Grain Structures Engineering Bulletin

Change: A rolled drip edge has been added to 40" and 30" diameter bin peak lids on all CB05-CB16 bins and hopper tanks.

9391364 - TOP LID 40" W/DRIP FLANGE W/30"CAP

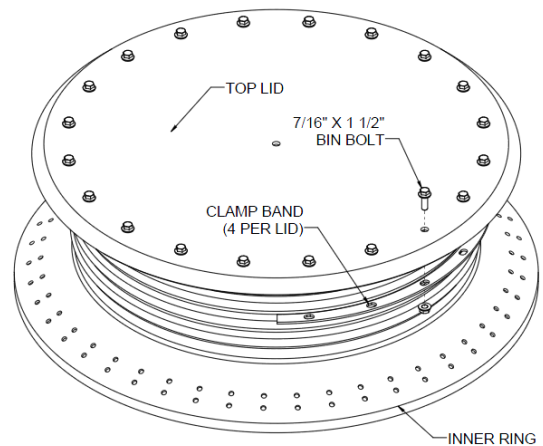
Note: Drip edge to provide improved watertight connection at peak.
